We have reviewed the General Electric Company topical report NEDE-20942-P, "Safety Relief Valve Discharge Analytical Model," and have identified the following three areas where additional information is required:

REQUEST FOR ADDITIONAL INFORMATION

Report Number: NEDE-20942-P

Report Title: Safety-Relief Valve Discharge Analytical Model, May 1975

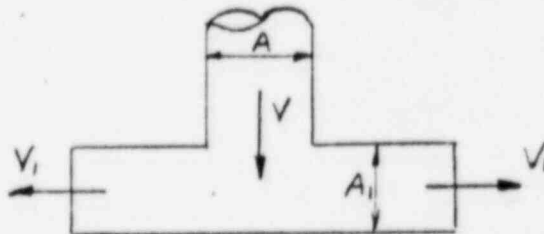
10. Identify which test of the Quad Cities' tests has been used for Figure 11.
11. On Page 50, Appendix B, it is stated that "the flow is sonic at both sections. . . .", while it is also stated on Page 11, Section 3.14 that "After the water plug is expelled, the air leaves the pipe at sonic velocity." The inconsistency of these two statements is illustrated by the following:

Appendix B specifies that the velocity V_1 is sonic, while Section 3.14 says V is sonic. Since A_1 is equal to A and flow rate passing A_1 is equal to one-half of that flowing through Section A , the velocity V_1 should be one-half of the velocity V . Explain this discrepancy and reanalyze the pool response if necessary.
